# HIGHWAY WORK PROPOSAL

<u>COUNTY</u>	<u>STATE PROJECT</u>	<u>FEDERAL</u>	<u>PROJECT DESCRIPTION</u>	<u>HIGHWAY</u>
Ozaukee	1229-04-76	WISC 2022007	I-43 North South Freeway; Highland Road To Sth 60	IH 043

## ADDENDUM REQUIRED ATTACHED AT BACK

Addendum No. 02  
ID 1229-04-76  
Revised Sheet 13  
November 1, 2021

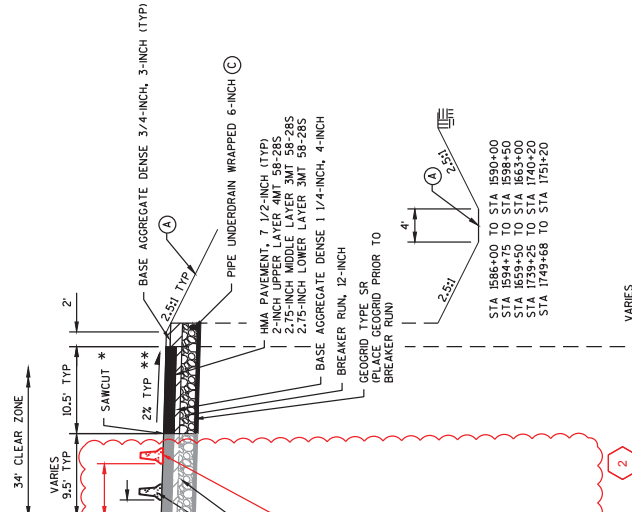
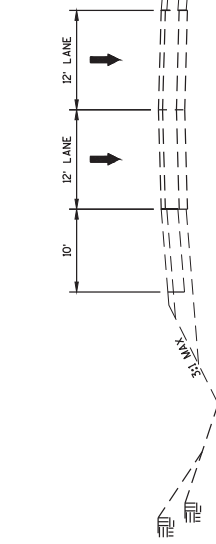
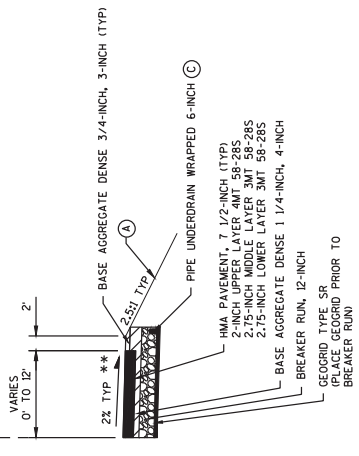
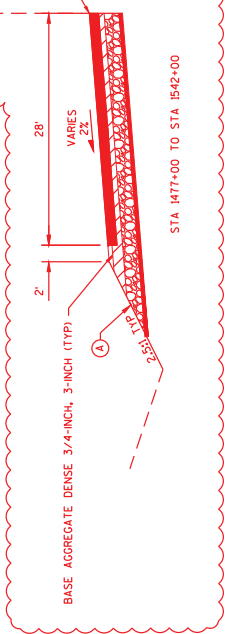
1147	Drainage Quantities: Lowered pipe from 694, changed stages of pipes from 692 & 693
1153	Drainage Quantities: Lowered pipe from 694, changed stages of pipes from 692 & 693, changed length of pipe from 694
1155	Drainage Quantities: Changed total of one bid item
1196	Miscellaneous Quantities (Added * to indicate additional quantities are shown elsewhere)
1197	Miscellaneous Quantities (Updated 'Detour Plan' table)
1957	General Layout S-45-0225 (Delete sign area note)
1991	Earthwork Data (Removed duplicate station range of data due to the addition of south temp crossover – new sheet 2002A below)
1992	Earthwork Data (Removed duplicate station range of data due to the addition of south temp crossover – new sheet 2002A below)

TYPICAL FINISHED SECTION  
IH 43 - STAGE IB  
STA 1477+00 TO STA 1542+00  
STAGE IB: PERFORM WORK AFTER  
PLACING CONCRETE BARRIER  
TEMPORARY PRECAST

Addendum No. 02  
ID 1229-04-76  
New Sheet 45A  
November 1, 2021

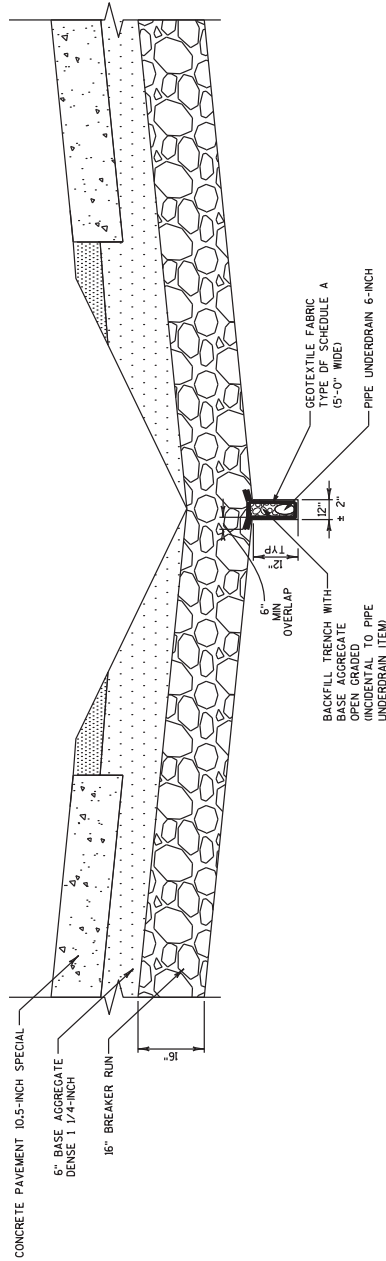
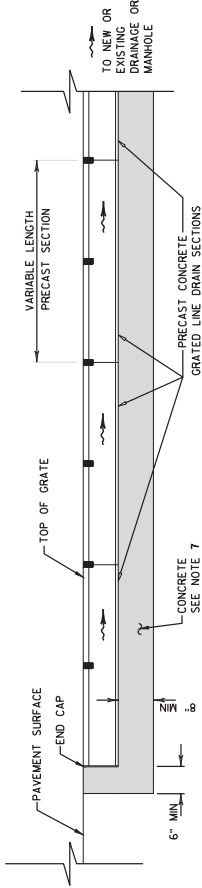
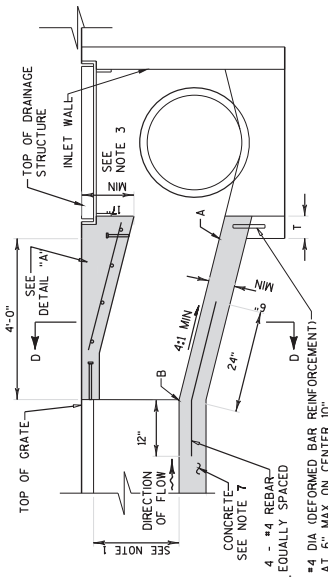
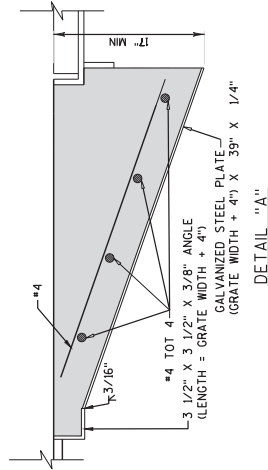
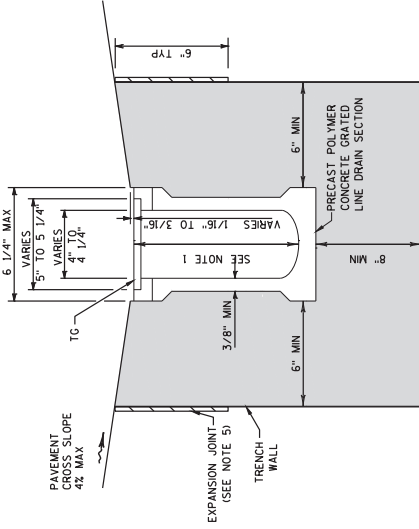
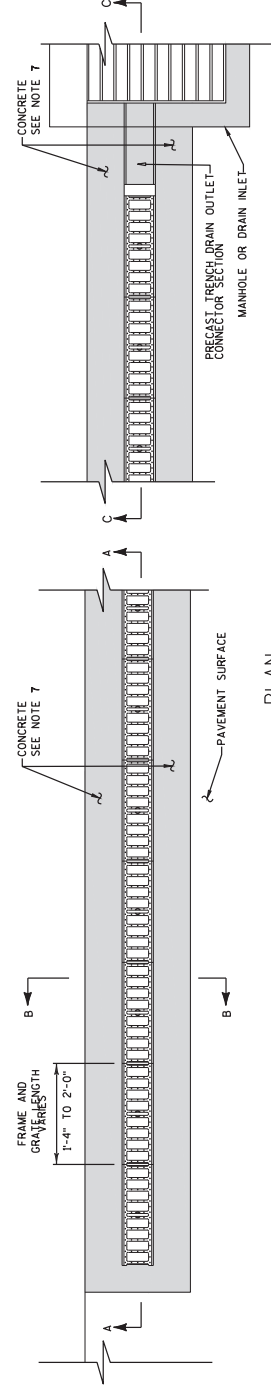
1. PROVIDE A 15-INCH DIAMETER DRAIN OR EQUIVALENT.
2. SUBMIT SHOP DRAWINGS FOR PRECAST TRENCH DRAIN SECTIONS SHOWING ALL OUTLET CONNECTIONS AND GRADES.
3. CONTRACTOR TO FIELD VERIFY MINIMUM DEPTH TO AVOID CONFLICT WITH INLET TOP, SPECIFICATIONS AND DETAILS.
4. PRECAST TRENCH DRAINS SHALL BE IN ACCORDANCE WITH MANUFACTURERS SPECIFICATIONS AND DETAILS.
5. PROVIDE A 1/4"-1/2" EXPANSION JOINT WITH AN EMULSIFIED JOINT FILLER BETWEEN CONCRETE PAVEMENT AND TRENCH DRAIN ENCASEMENT.
6. CONTRACTOR TO FIELD VERIFY MINIMUM DEPTH TO AVOID CONFLICT WITH CASTINGS, RINGS OR STRUCTURE DECK.
7. CONCRETE GRADE SHALL MATCH ABUTTING MAINLINE CONCRETE PAVEMENT, UNLESS OTHERWISE APPROVED BY THE ENGINEER.

Addendum No. 3  
 ID 1229-04-76  
 Revised Sheet 553  
 November 5, 2021

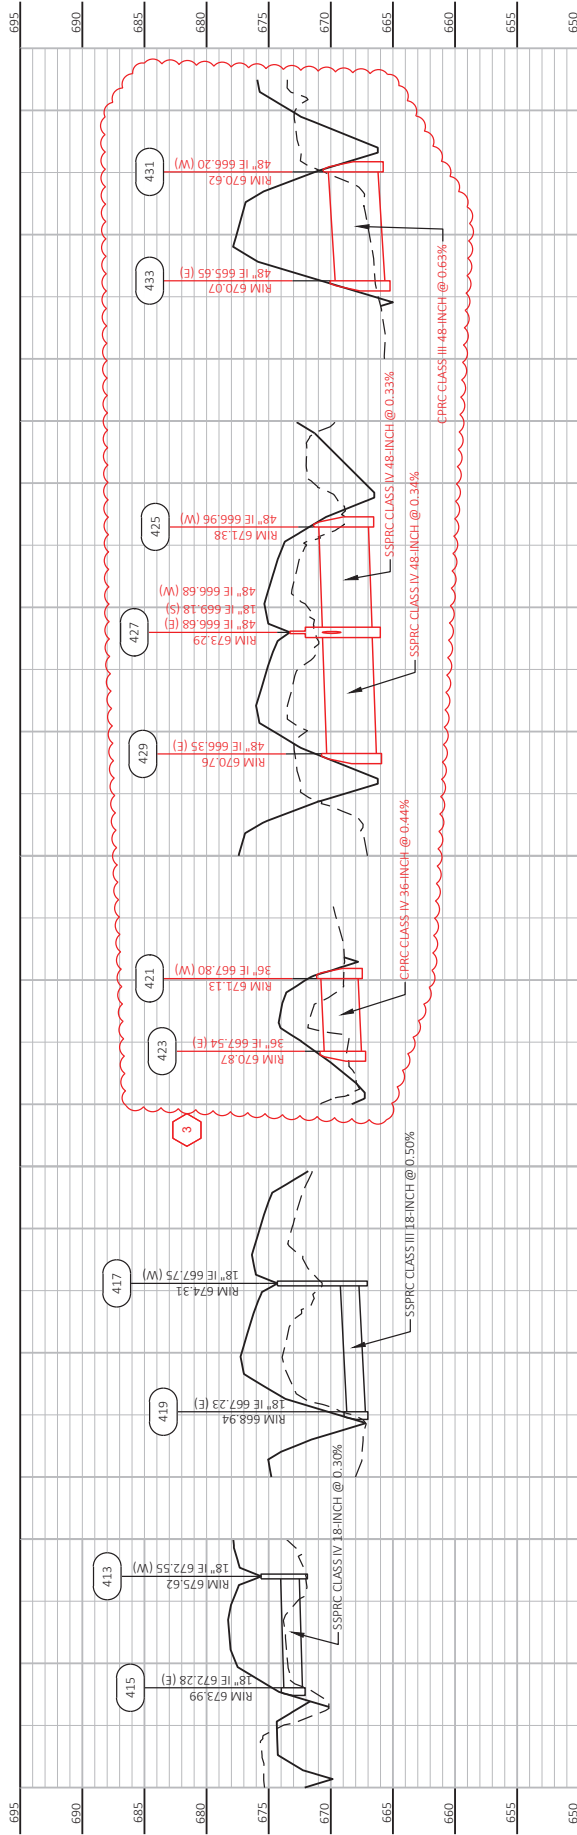
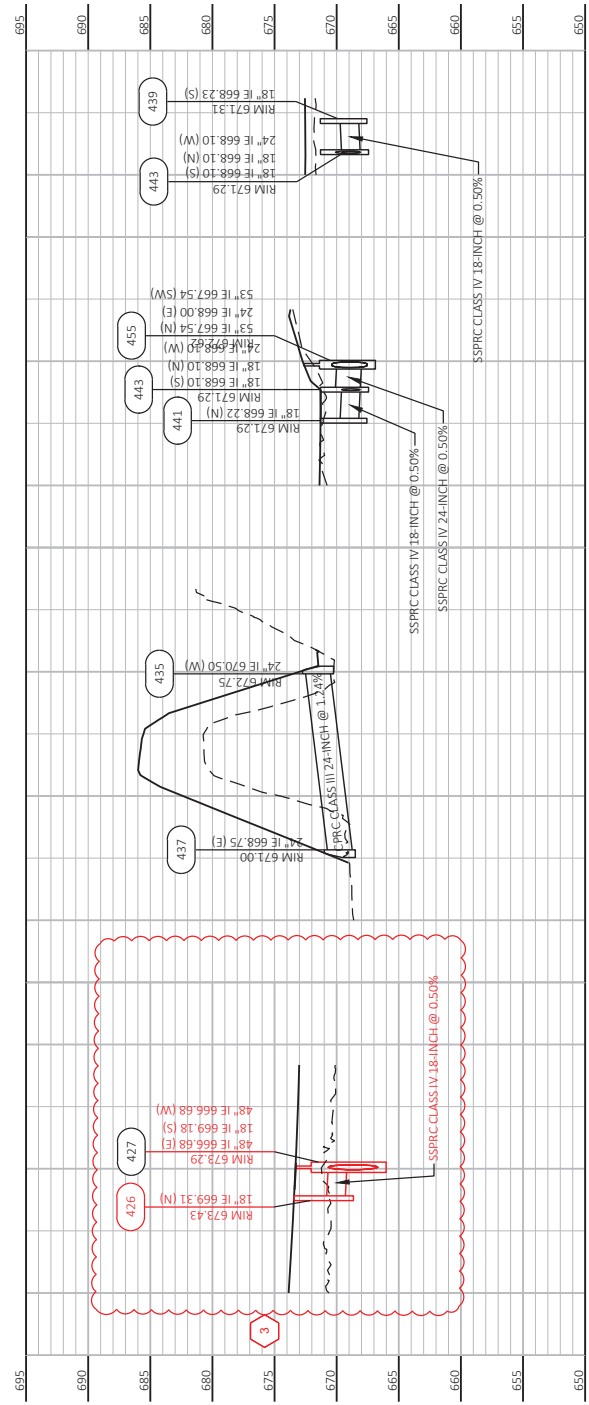
\*CONTRACTOR TO MAINTAIN WATERWAY FLOW WITH TEMPORARY PIPES  
 OR OPEN DITCH WHEN REPLACING EXISTING PIPES.
